**IN THE DRAWINGS:**

## REMARKS

ANNOTATED SHEET  
SHOWING CHANGES

FIG 1

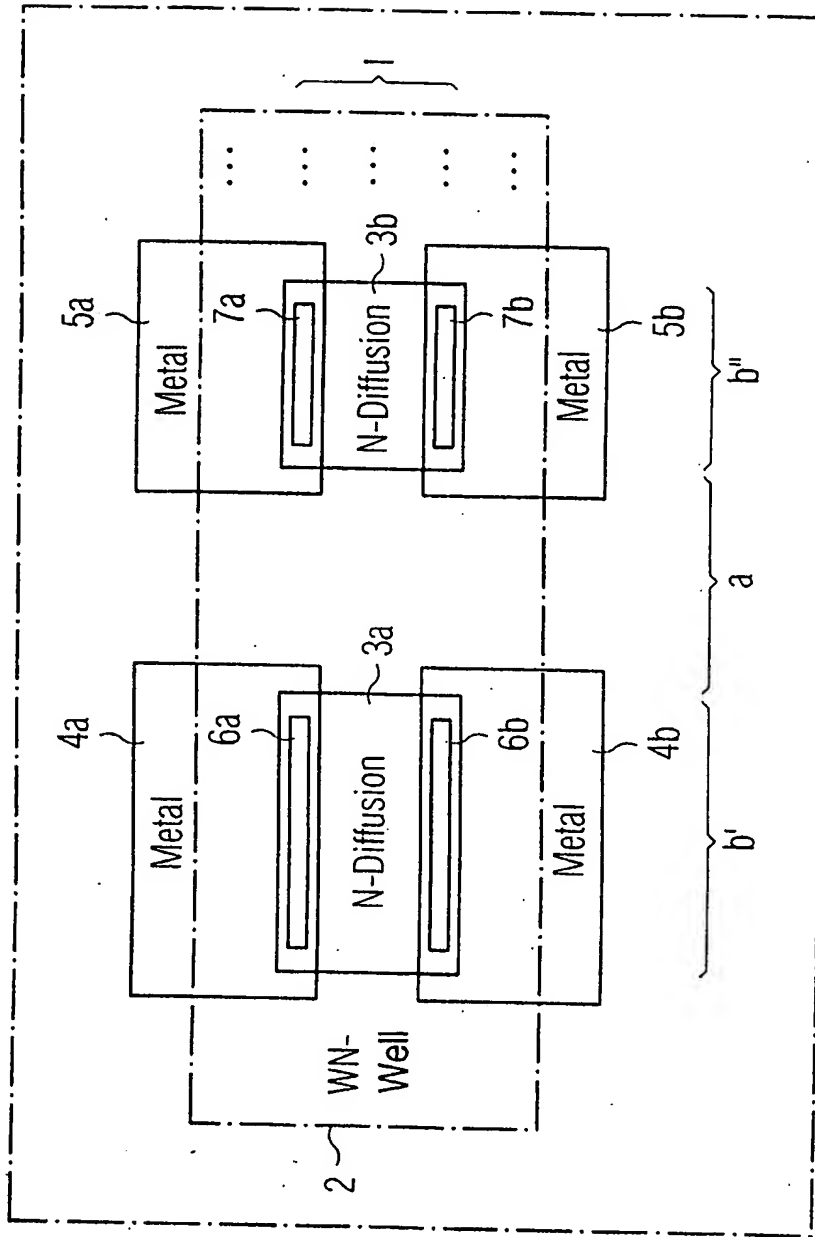
The attached sheet of drawings includes changes to Fig. 1 and replaces the original sheet 1. The previously omitted words "PRIOR ART" have been added to Fig.1. A sheet marked "Annotated Sheet Showing Changes" and a sheet marked "Replacement Sheet" are enclosed.

Support for the amendment to the Drawing is found at least in the Brief Description of the Drawings on page 4, and in Paragraph 36, both of which indicate that Fig. 1 is prior art.

PRIOR ART
